Nuclear Products Division

Subject: Response to Request for Additional Information (TAC L31836)

Enclosure I
BWXT Response to RAI Questions

Environmental Report

Figure 3-4 Demographic Distribution within 50 miles of the BWXT Site

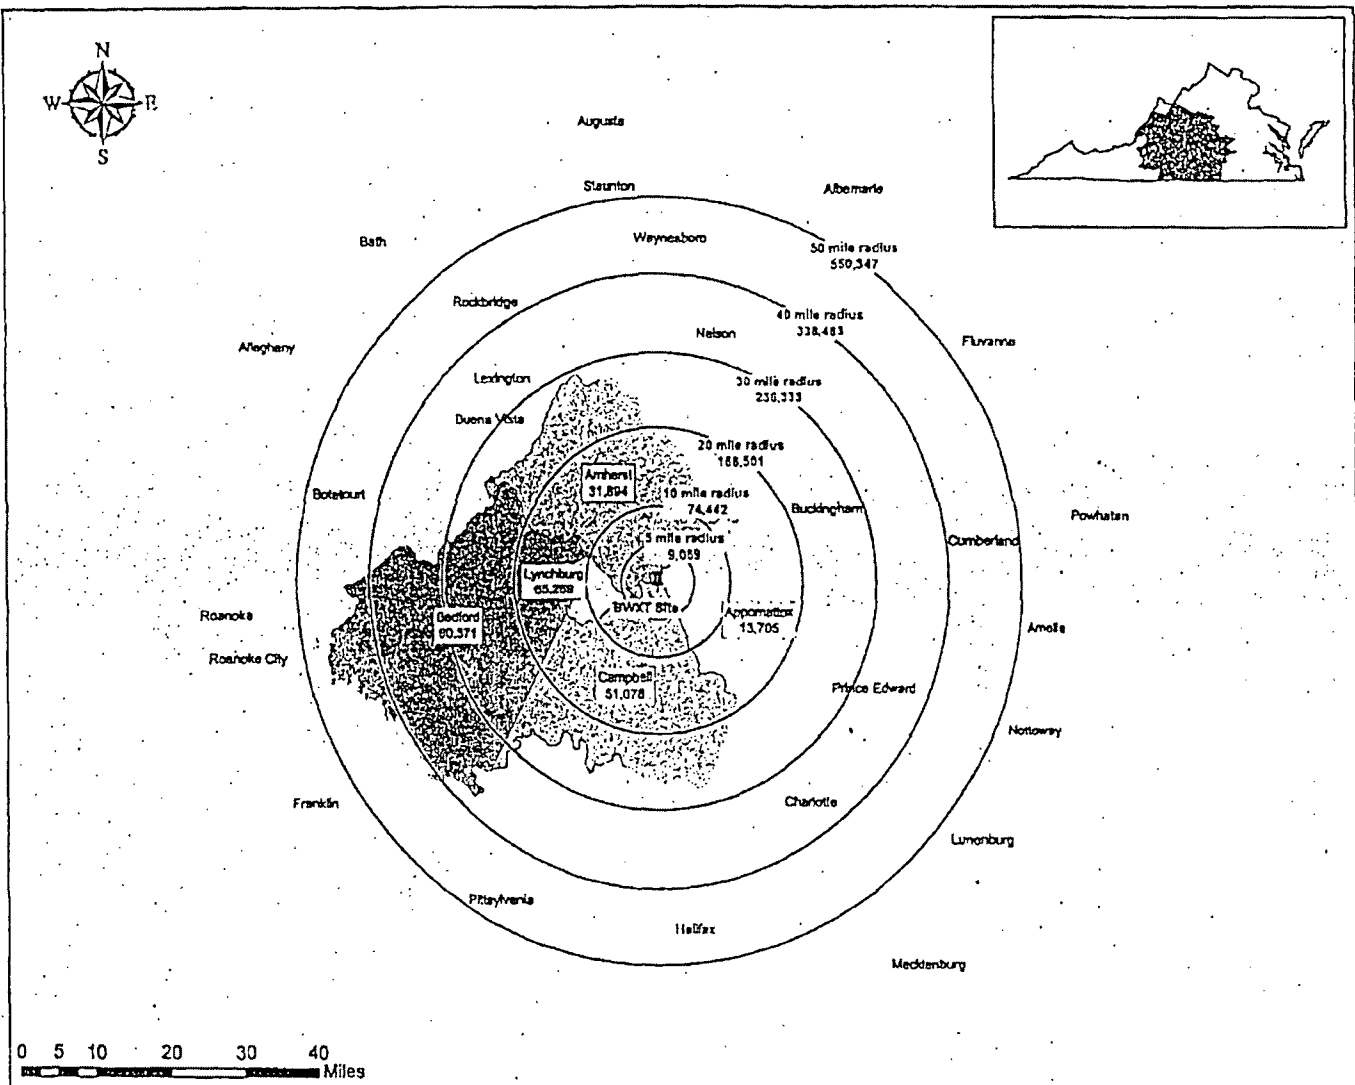
3. Update Population Distribution Data around BWXT Site

Clarify the current population distribution in the vicinity of the BWXT facility. Since the last license renewal in 1995, population and income data from the 2000 Census (**U.S. Census Bureau, 2004**) have become available. The total population for Lynchburg and a three-county region of influence has been

included in the March 10, 2004, environmental report (ref. 1). The population distribution, however, was not updated to reflect the new information. BWXT should provide updated population distribution data similar to the 1995 supplemental environmental assessment (ref. 4), Table 3.4 and Figure 3.1 or a rationale for why such an update is not necessary to assess the socioeconomic and public health impacts from the proposed action.

BWXT RESPONSE:

Section 3.10 of the Environmental Report has been revised to include updated population distribution data.

Figure 3-5 NPD OSHA Rate

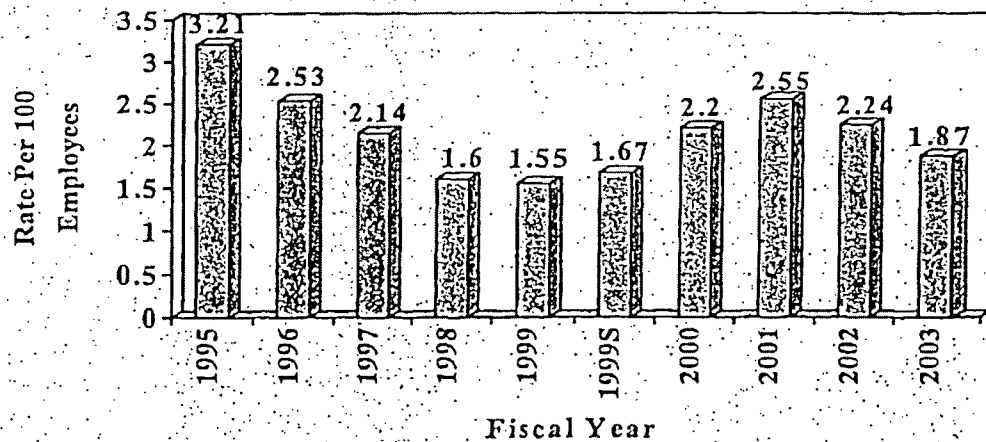
8. Explain BWXT Incident Rates

Describe the BWXT Occupational Safety and Health Administration (OSHA) incident rate in detail: Section 3.11.2 of the environmental report (ref. 1) states that the average OSHA incident rate from 2000 to 2003 was 1.8. BWXT should provide units for this value and compare this incident rate to industry standards.

BWXT RESPONSE:

section 3.11.2 of the Environmental Report has been revised to describe the OSHA incident rate and to compare this incident rate to industry standards.
